City of Albuquerque

***RE: ALBERTSON'S SHOPPING CENTER - VIDEO UPDATE (K10-D27). GRADING
AND DRAINAGE PLAN FOR FOUNDATION PERMIT AND BUILDING PERMIT
APPROVALS. ENGINEER'S STAMP DATED OCTOBER 16, 1998.***

RE: ENGINEER'S CERTIFICATION FOR ALBERTSON'S AT CENTRAL & COORS
(K-10/D27)
RECEIVED JUNE 19, 1996 FOR CERTIFICATE OF OCCUPANCY
ENGINEER'S STAMP DATED 4-1-96

RE: DRAINAGE REPORT FOR ALBERTSON'S AT CENTRAL & COORS (K-10/D27)
RECEIVED SEPTEMBER 20, 1995 FOR SITE DEV PLAN & BUILDING PERMIT
ENGINEER'S STAMP DATED 9-20-95

GRADING & DRAINAGE PLAN

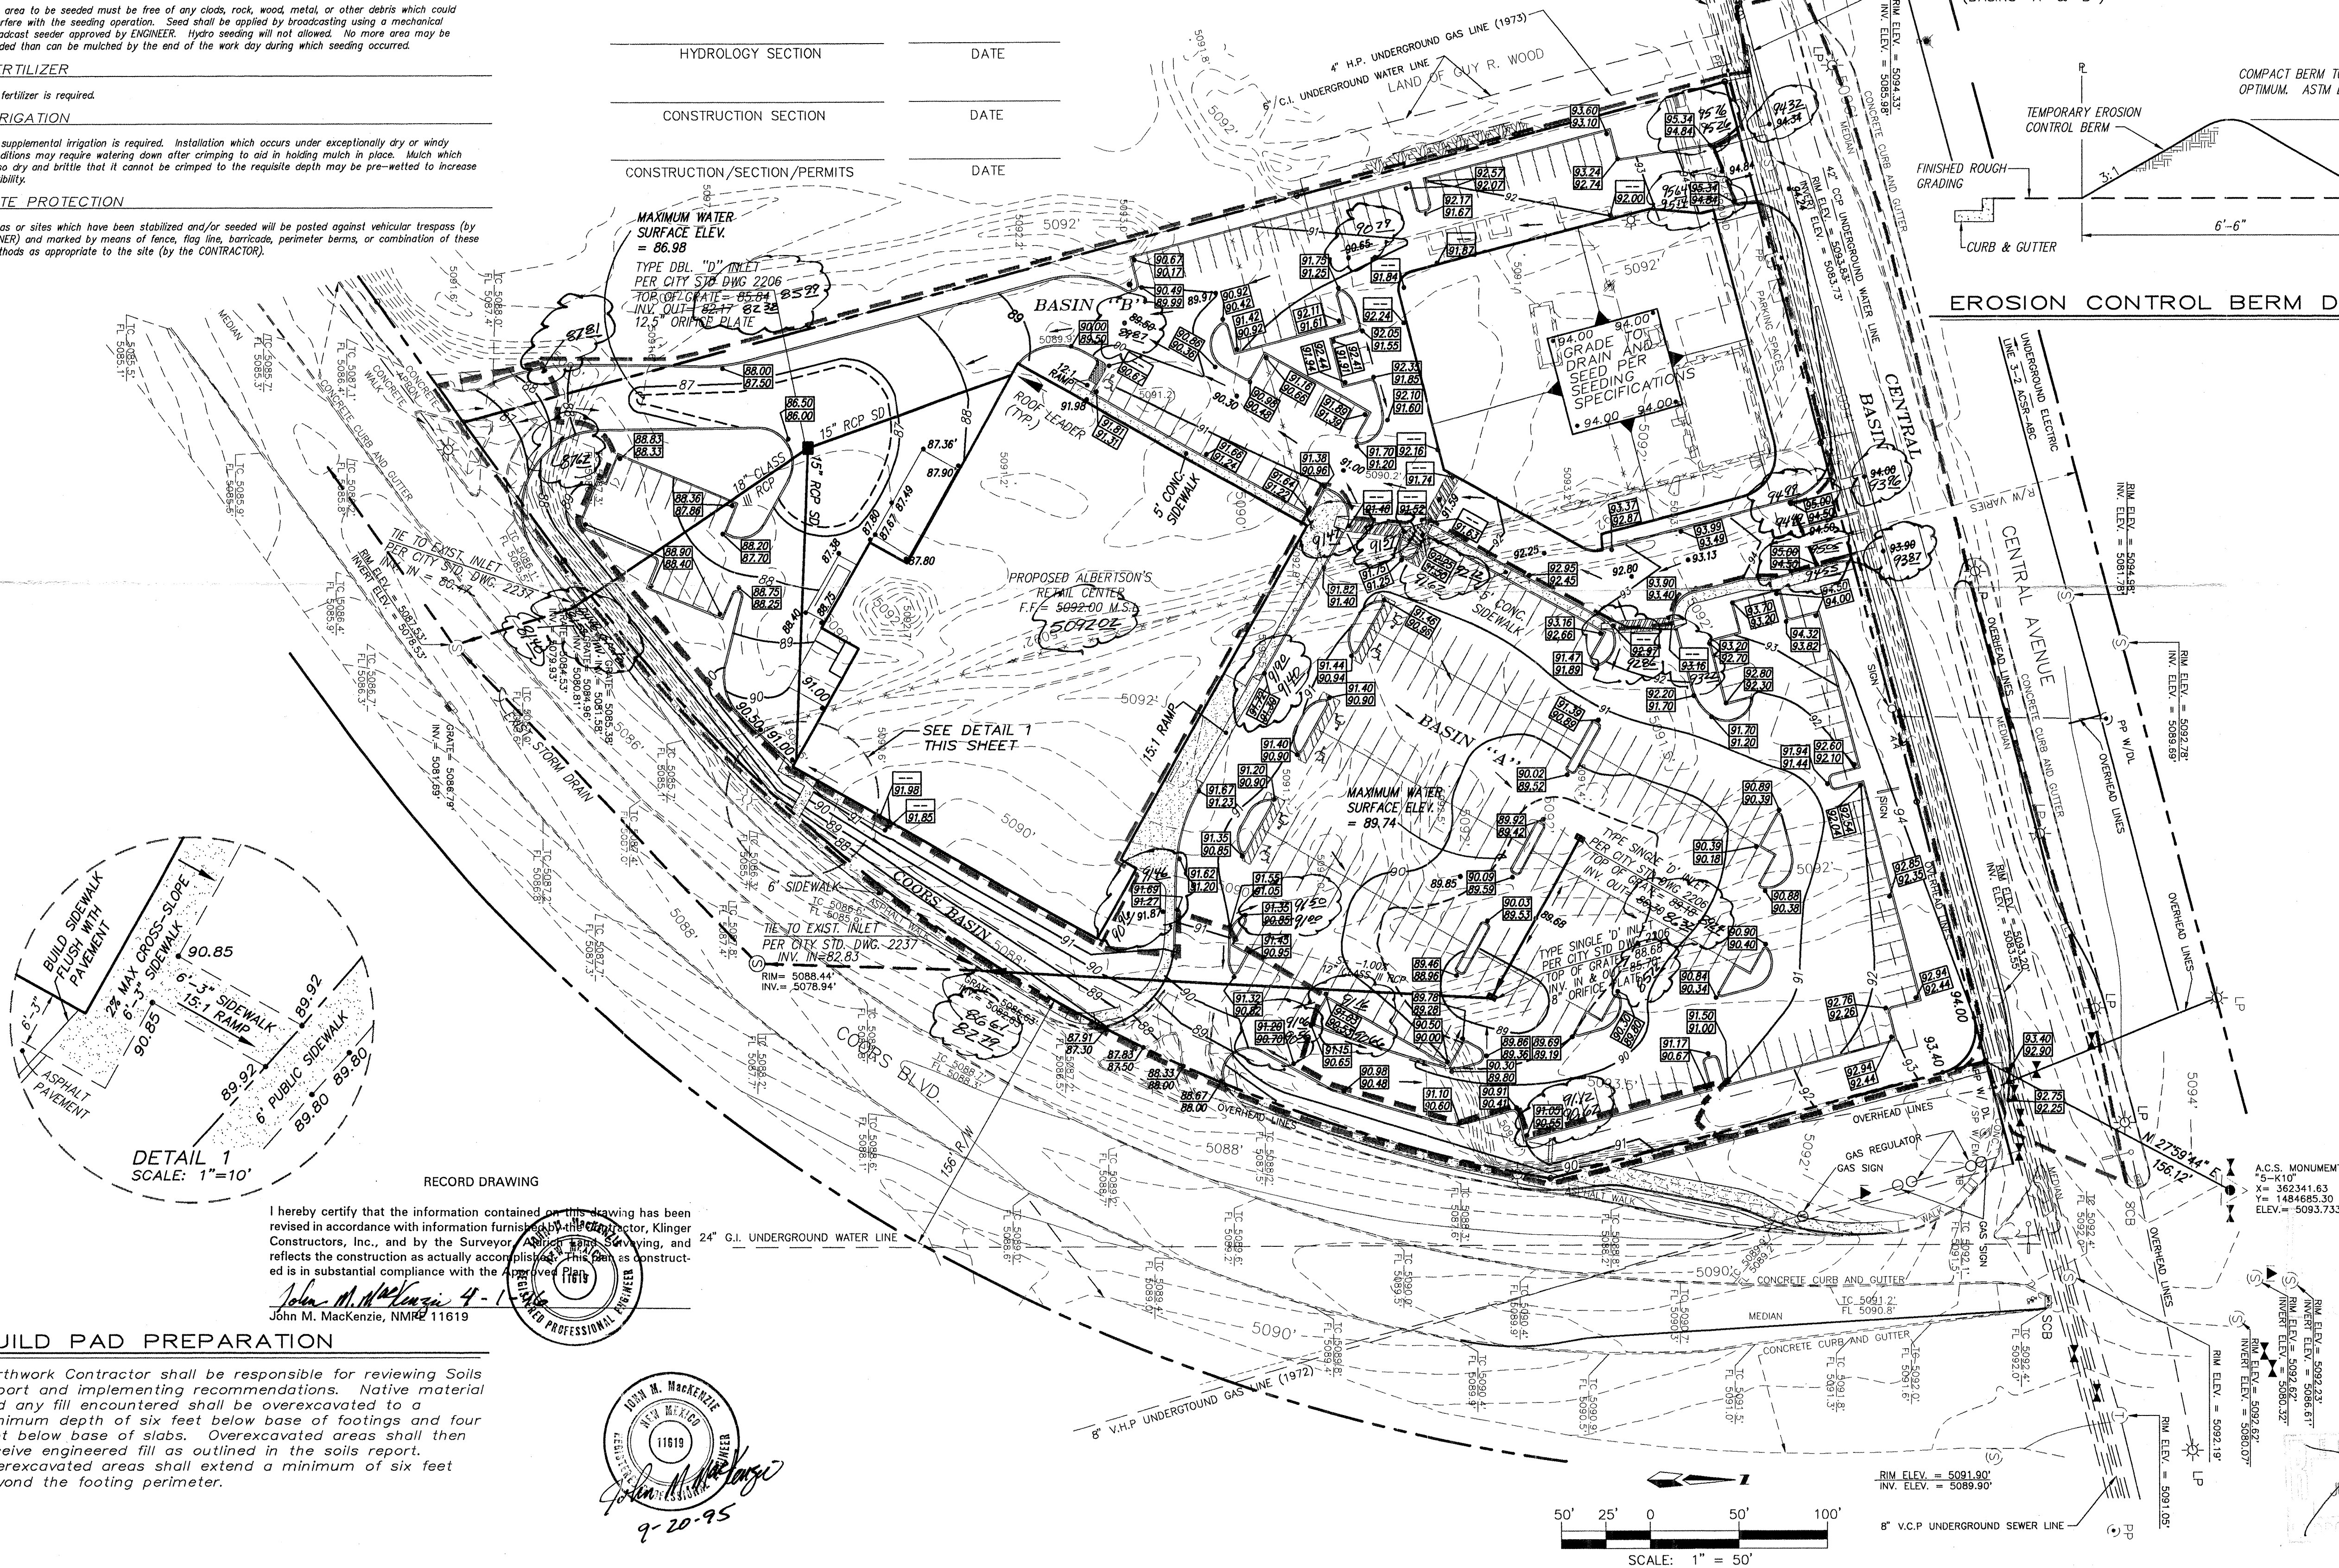
1. Indicate the boundary of the Off Site Basin. Adequate water blocks must be provided at entrances on Central. If Central will not drain to Coors, Then a temporary solution will be required. Obtain an access easement from the owner of Tract 60 for the western entrance on Coors.

2. An erosion control plan will be required for rough grading. A proposed Infrastructure List will be required for Preliminary Plat.
3. Indicate the Maximum Water Surface Elevation and extent of ponding for both ponds. Detail both orifice plates. It is not clear how the outflow values for the route reservoir command were calculated. Add Hydrograph 101.3 & 101.5 to determine the peak flow from the site.

4. The boundary between Basin A & B, north of the Albertson's building appears artificial. Verify that runoff will actually split along this divide. Is another basin necessary to indicate the runoff that discharges directly to Coors?
